**FINAL  
NEGATIVE DECLARATION  
VENTURA COUNTY MEDICAL CENTER  
PARKING LOT IMPROVEMENTS PROJECT**

**SCH NO. 2023010327**

**March 2023**

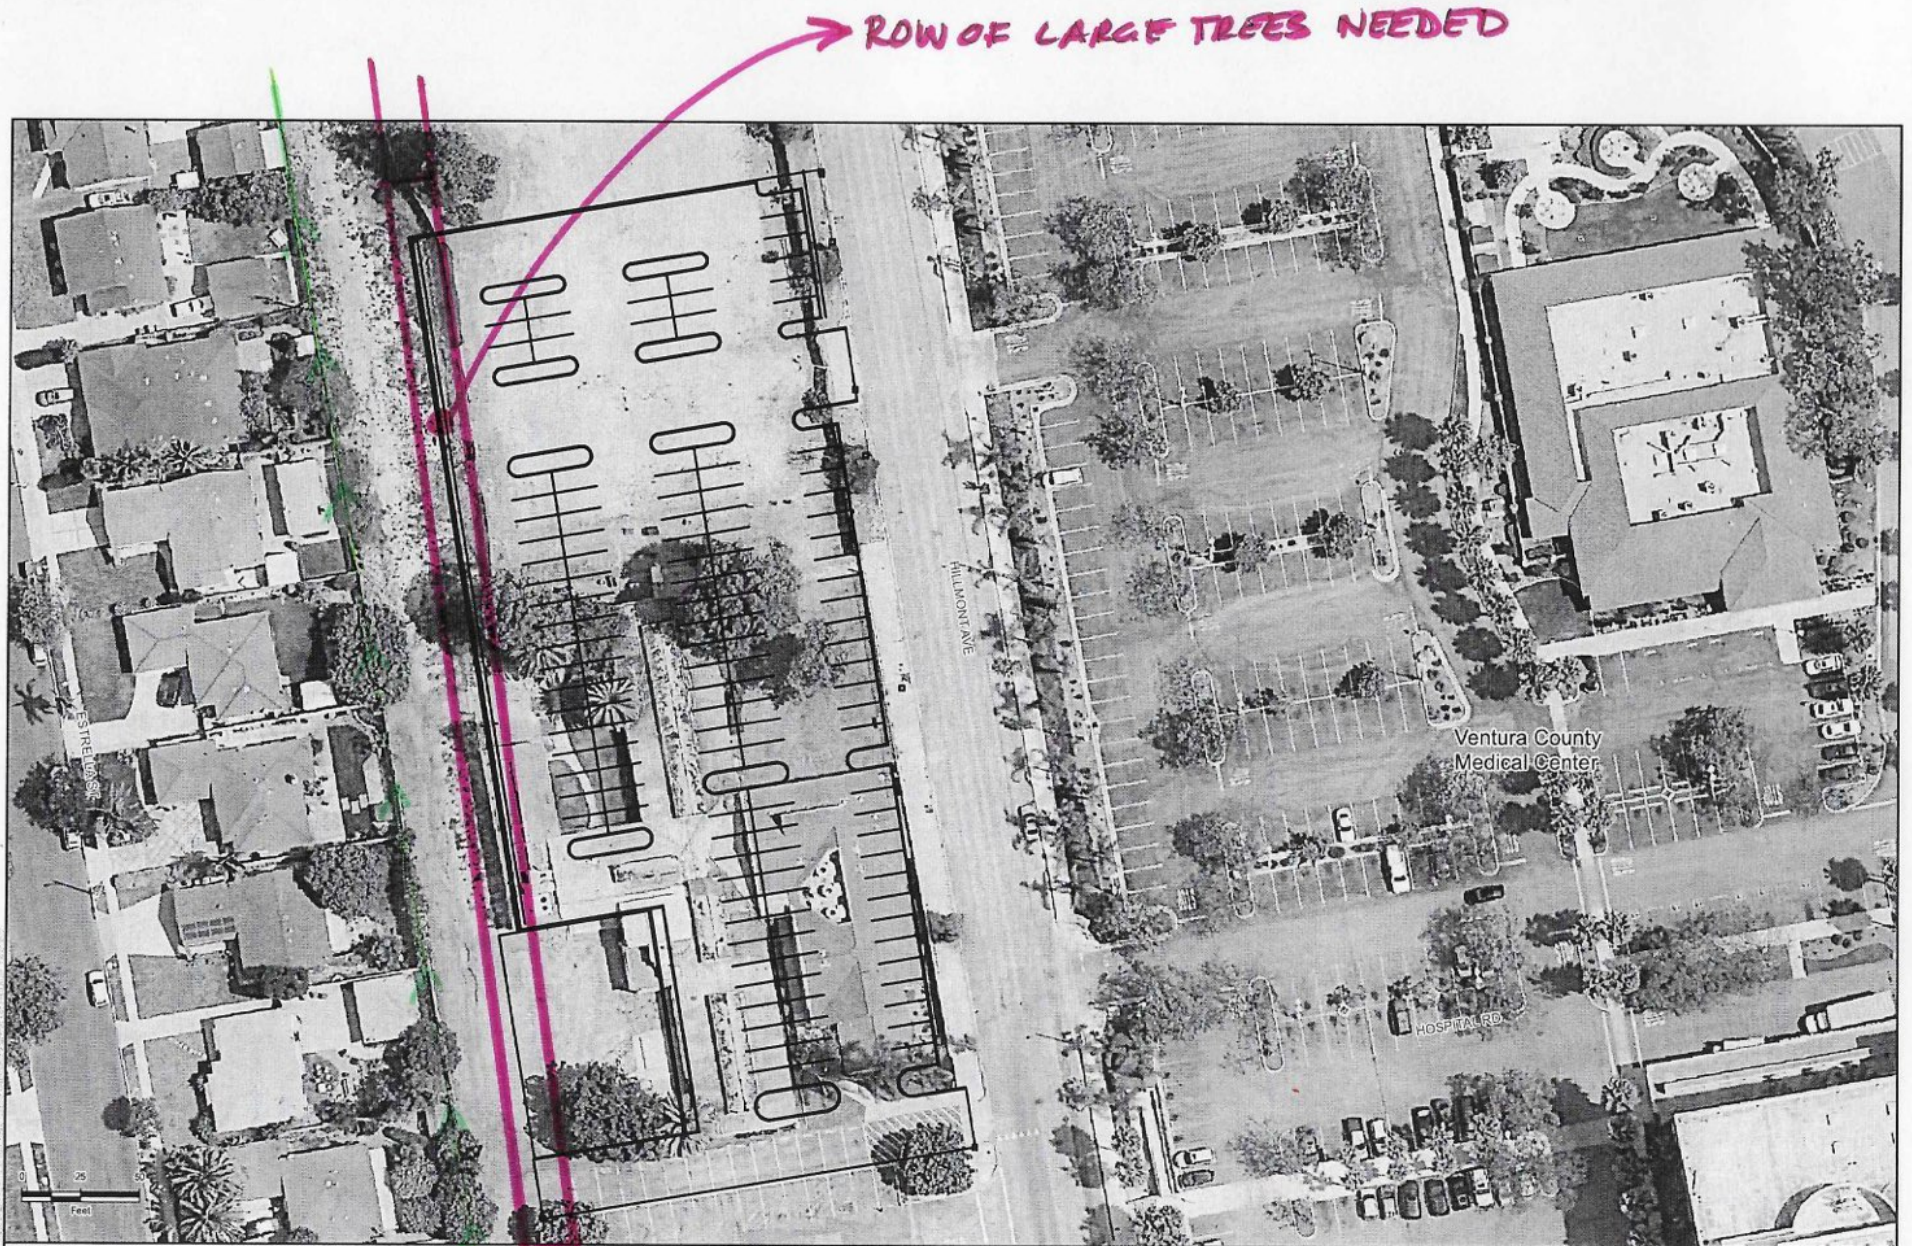
- a. Plan View outlining proposed additional screening landscaping by planting row of tall dense foliage trees by the County.
- b. images of newly occurring light pollution being experienced (from all the way across Hillmont) into our backyards and before image of backyard vista over the Colston Bldg.

Please recognize that we as residents, do not have the ability to plant large trees on our properties considering that we bear the burden of the Utility Easement on our East Property Lines.

Large trees on our property would interfere with the public utility power pole lines.

**Response:**
